# HISTORIC AND DESIGN REVIEW COMMISSION

October 02, 2019

**HDRC CASE NO:** 2019-298  
**ADDRESS:** 111 SOLEDAD ST  
**LEGAL DESCRIPTION:** NCB 909 BLK LOT 17  
**ZONING:** D, H, RIO-3  
**CITY COUNCIL DIST.:** 1  
**DISTRICT:** Main/Military Plaza Historic District  
**APPLICANT:** Ashley Farrimond/Kaufman & Killen, Inc.  
**OWNER:** RIVERVIEW TOWER PRTNR LTD  
**TYPE OF WORK:** Exterior modifications, fenestration modifications, site work, lighting and signage  
**APPLICATION RECEIVED:** September 13, 2019  
**60-DAY REVIEW:** November 12, 2019  
**CASE MANAGER:** Edward Hall  
**REQUEST:**

## ROOF PLAN

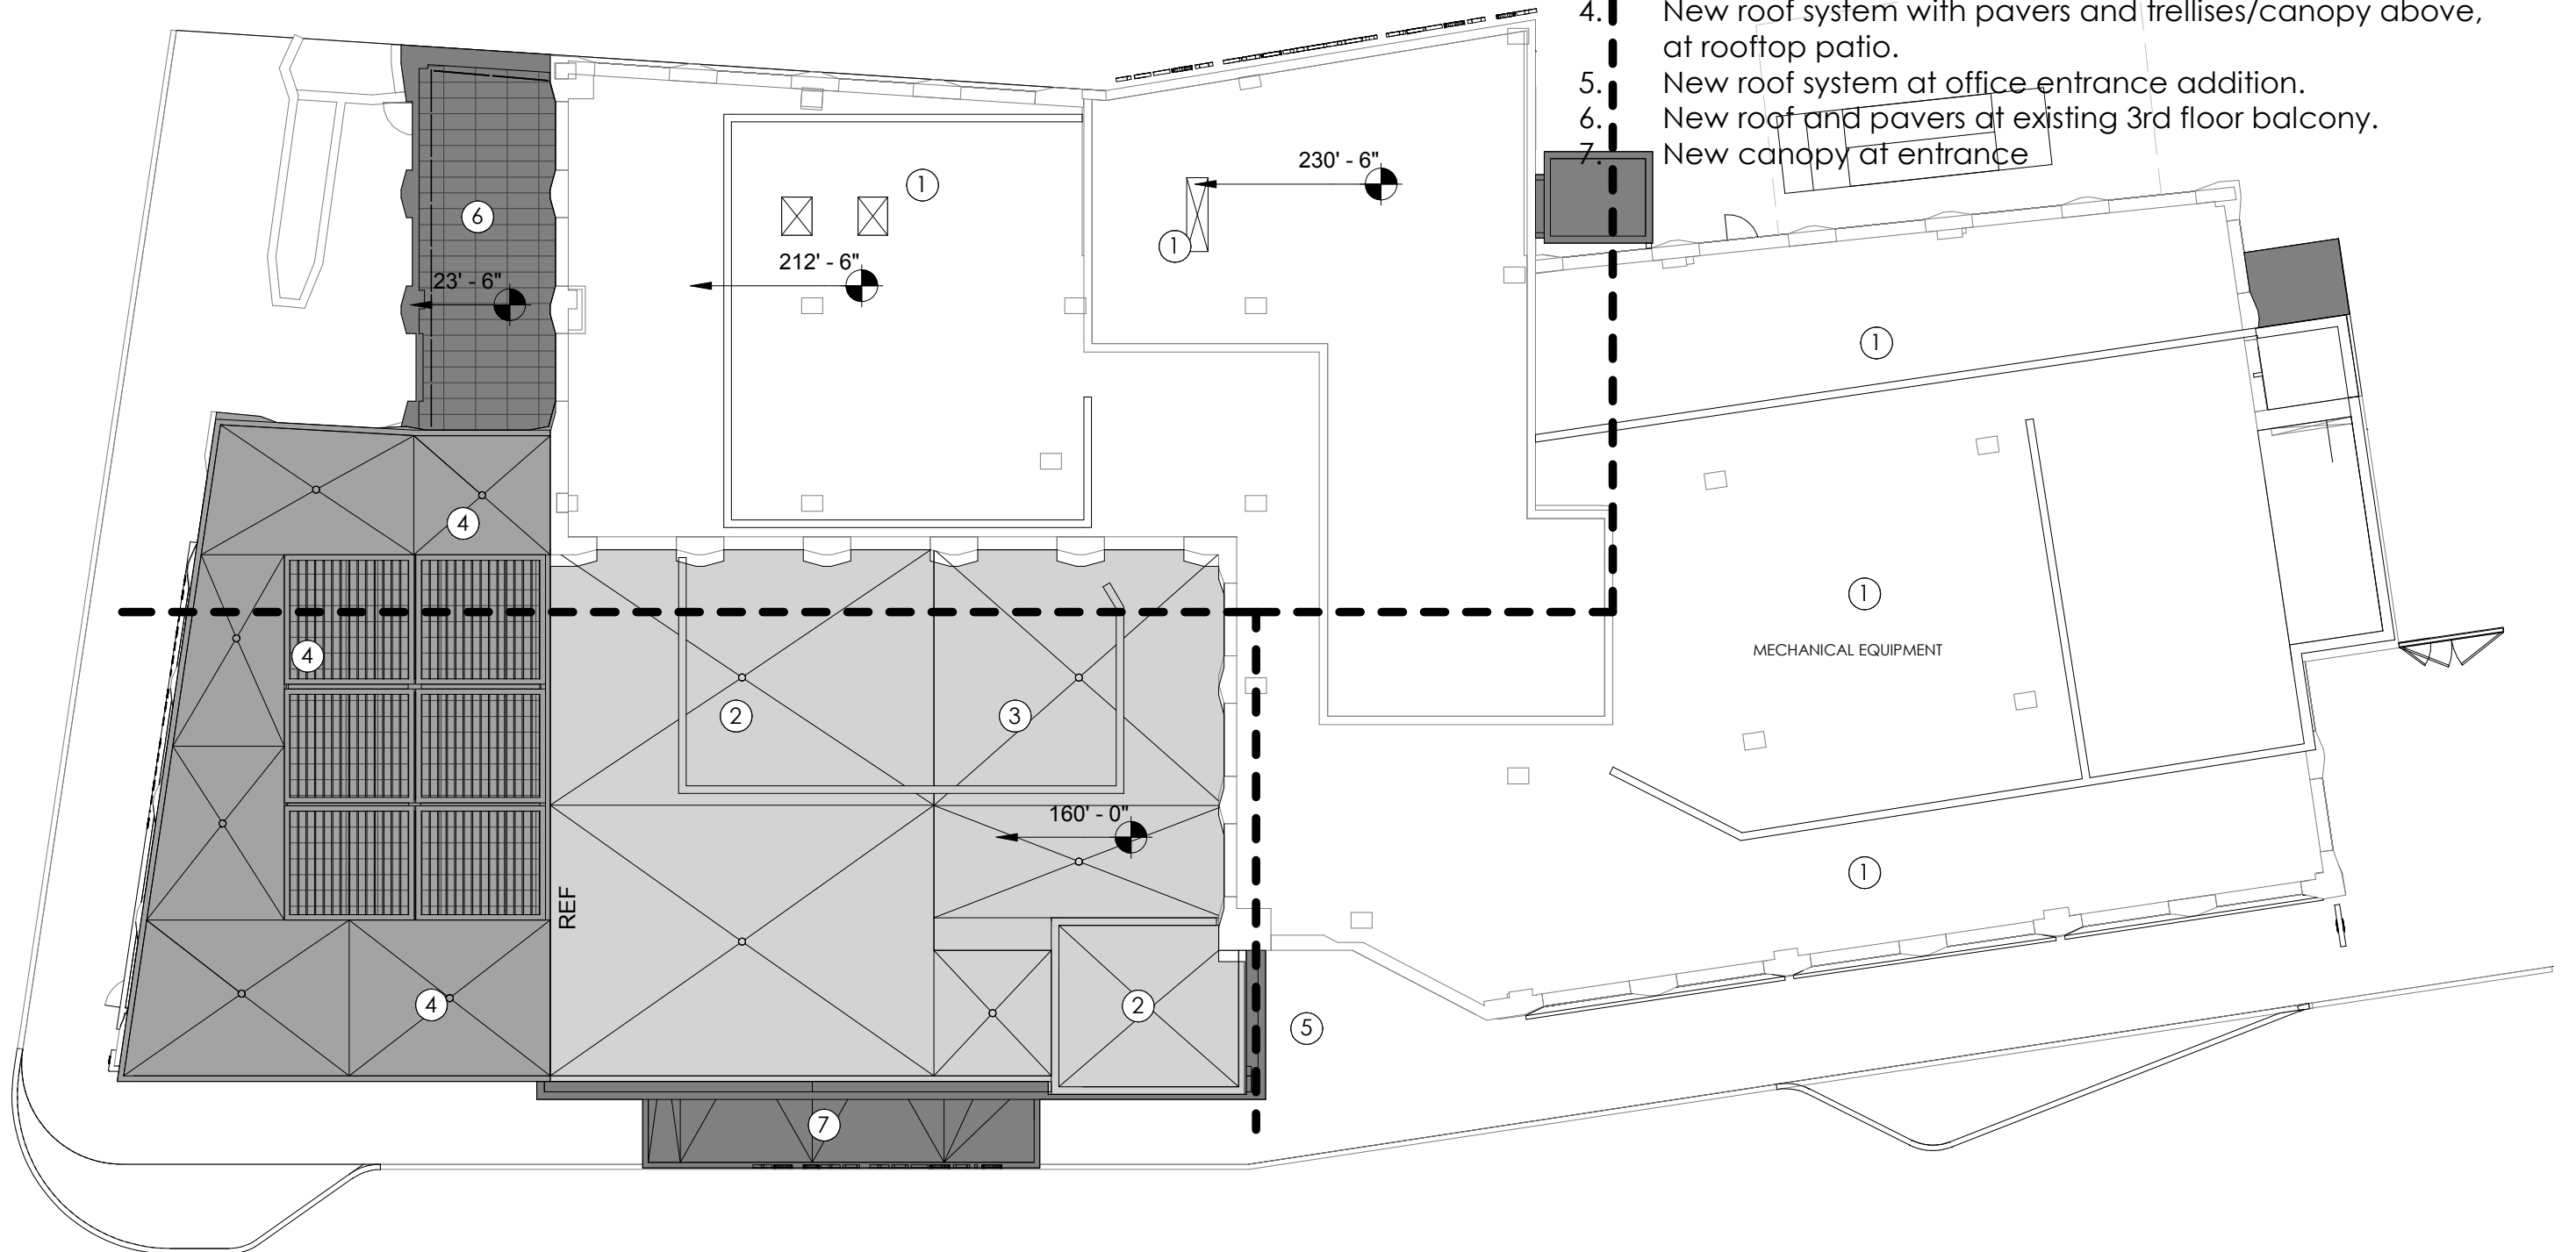
- d. EXTERIOR MODIFICATIONS (Vertical circulation) – The applicant has proposed to modify the east (Soledad) façade to include new façade materials oriented in a vertical emphasis to the proposed rooftop terrace to differentiate the circulation element from existing façade elements. Staff finds the proposed modification appropriate as it further creates façade separation. Additionally, the proposed modification creates an architectural focal point. This is consistent with the UDC.

## SOLEDAD ELEVATION

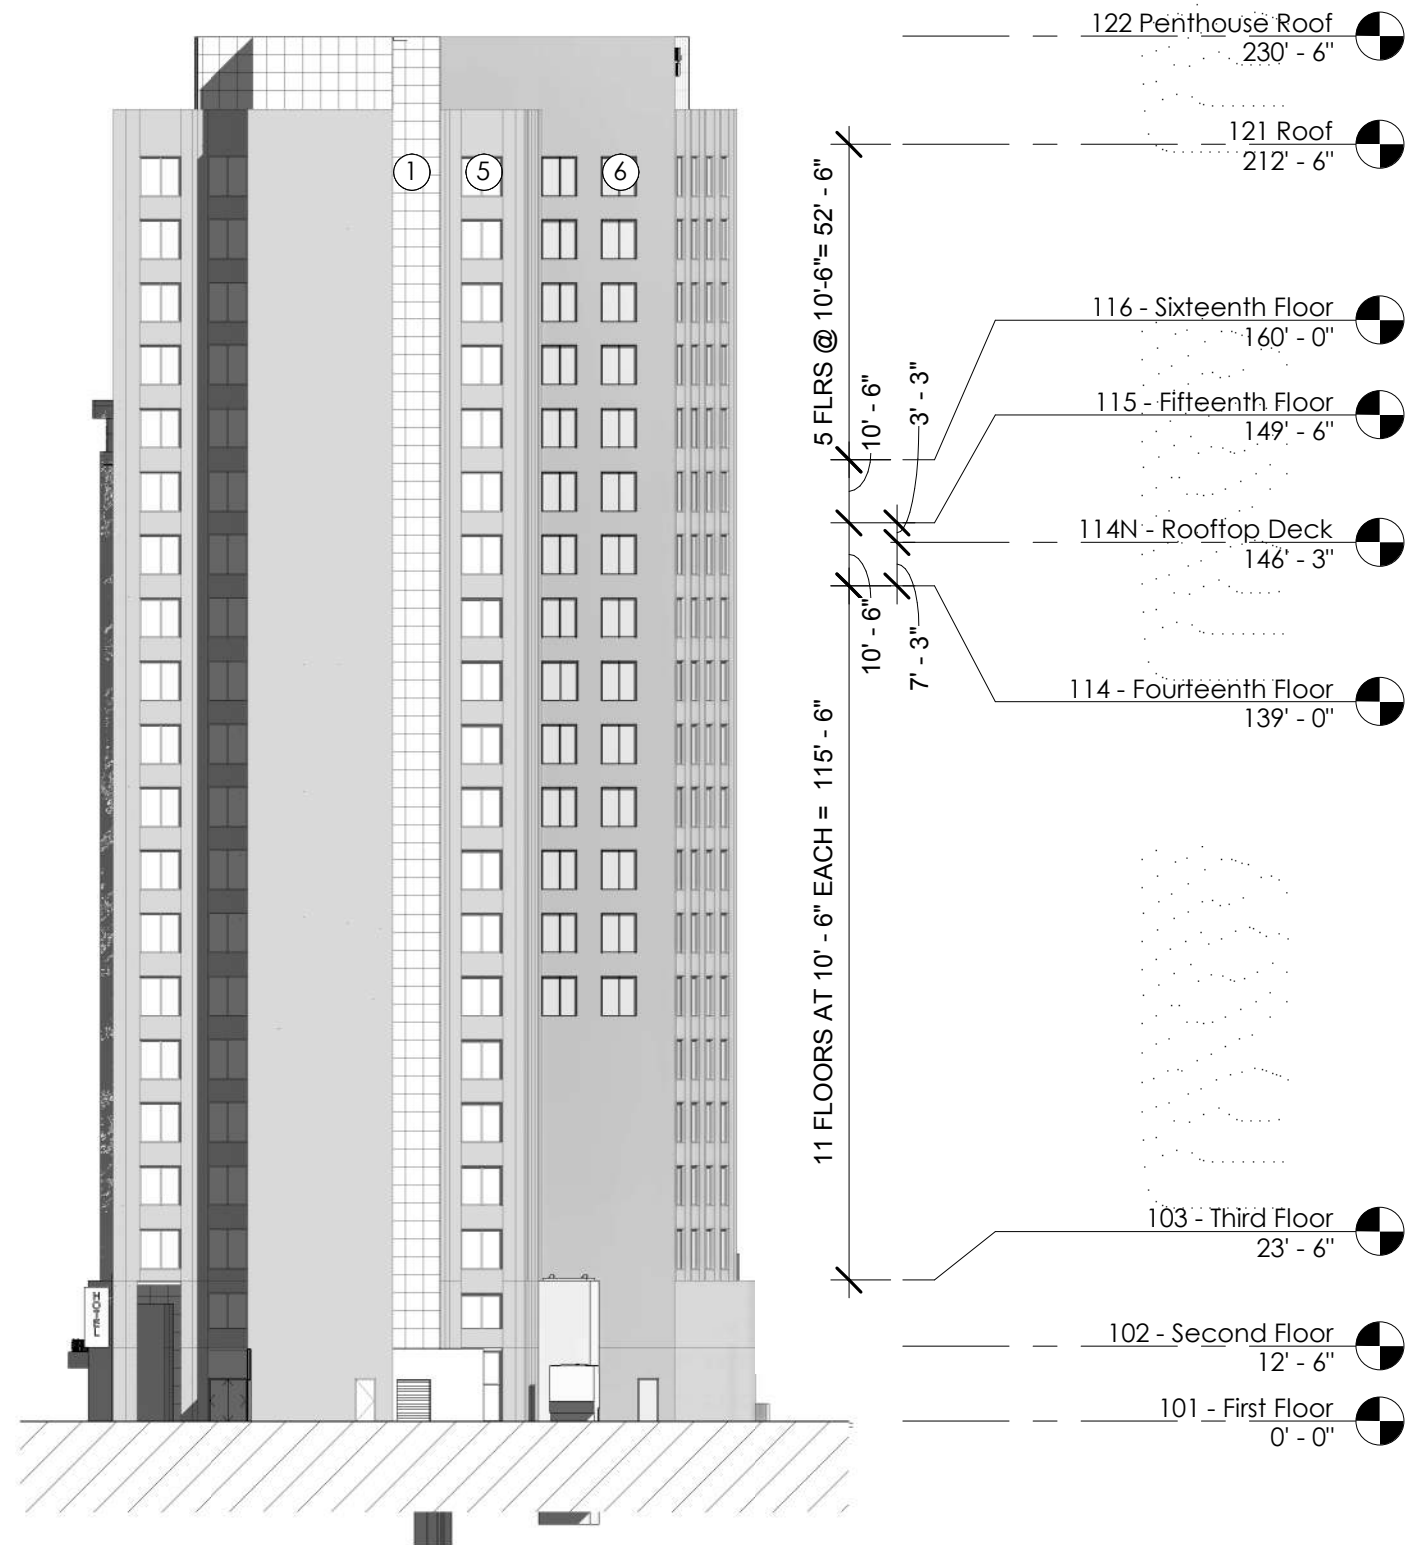
- e. EXTERIOR MODIFICATIONS (Street level) – The applicant has proposed to modify the street level façades on both Soledad (east) and E Commerce (south) to feature entrance elements that more adequately address pedestrian traffic and the human scale. These modifications include the installation of entrance canopies, in addition to new and detailed pedestrian entrances. The UDC Section 35-673 provides standards for pedestrian entrances, including arranging entrances in a hierarchy. The UDC Section 35-674 notes that entrances shall be the most prominent on streets, shall be places to be highly visible, shall have a change in material and/or wall plane and should not use excessive storefront systems. The proposed modifications to entrances on both Soledad and E Commerce and consistent with the UDC.

- h. SIDEWALK – At the street level on Soledad, the applicant has proposed to modify the existing sidewalk to feature a vehicular access point to accommodate valet parking. This would require the removal of portions of the public sidewalk; however, the applicant has noted that the existing pedestrian pathway within the structure's existing colonnade would be open to pedestrians. Per the submitted site plan, a width of six (6) feet will be maintained on the sidewalk at all times. The applicant shall coordinate with the City of San Antonio Center City Development Office, Transportation and Capital Improvements and the Disability Access Office in regards to the street level details, width of public walkways and public access across the site.

- i. That the applicant coordinate with the City of San Antonio Center City Development Office, Transportation and Capital Improvements and the Disability Access Office in regards to the street level details, width of public walkways and public access across the site.
- ii. That a width of six (6) feet in width is maintained between the curbcut and building façade at all times.
- iii. That all signage feature indirect illumination and metal construction. All acrylic faces should be modified to metal faces and back lighting, or indirect lighting should be incorporated. Signage details for all signage including materials and installation methods are to be submitted to staff for review and approval prior to installation.

## WEST ELEVATION

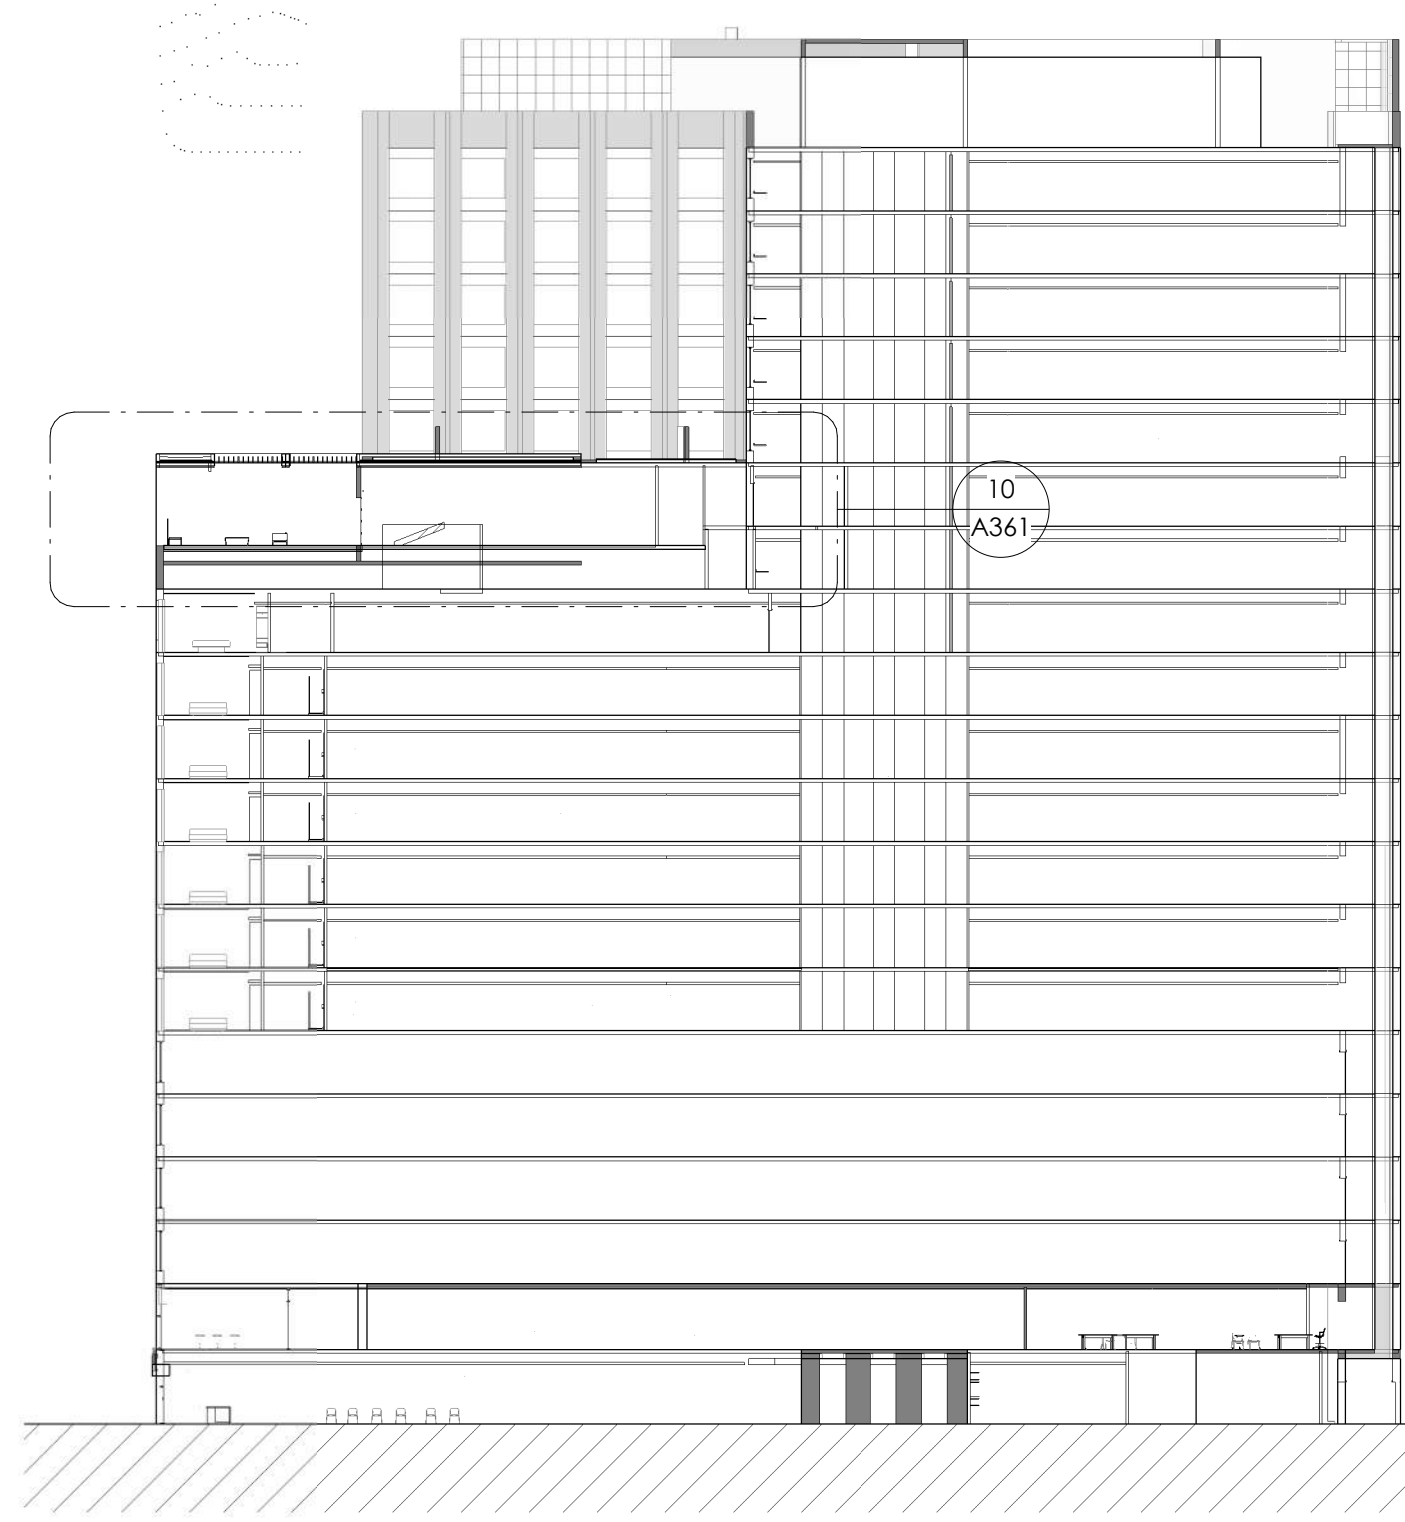
- f. EXTERIOR MODIFICATIONS (West façade) – The applicant has proposed to add two columns of windows on a northern facing wall portion on the west façade. Staff finds the proposed additional fenestration to be appropriate and consistent with the UDC.
